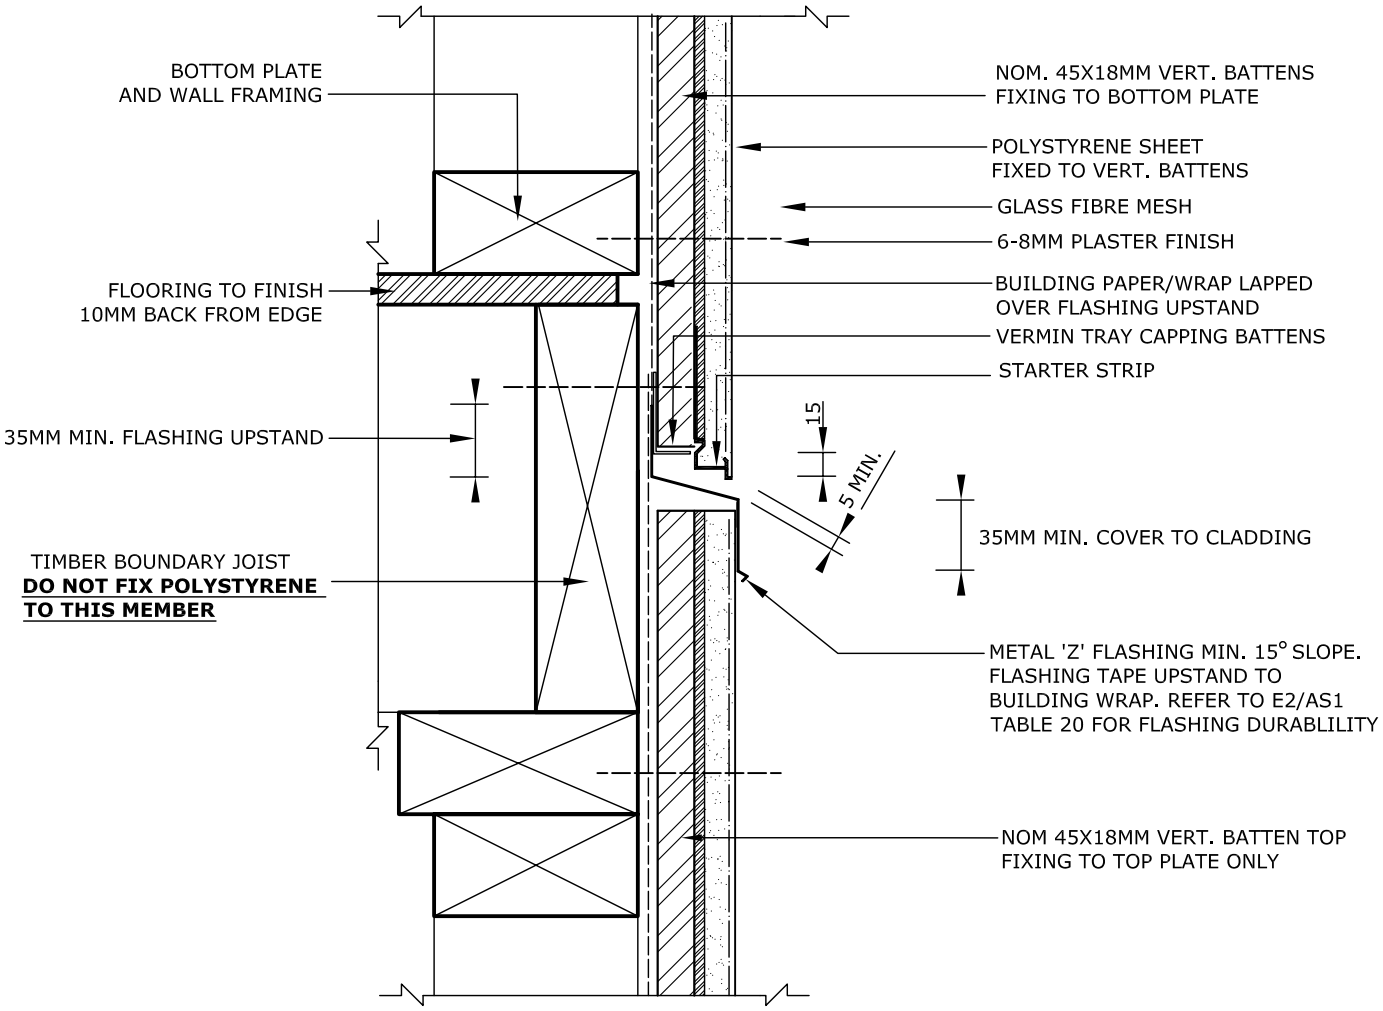
THIS DETAIL IS REQUIRED AT THE SECOND STOREY JOIST LEVEL. REFER TO E2/AS1 Clause 9.1.9.4
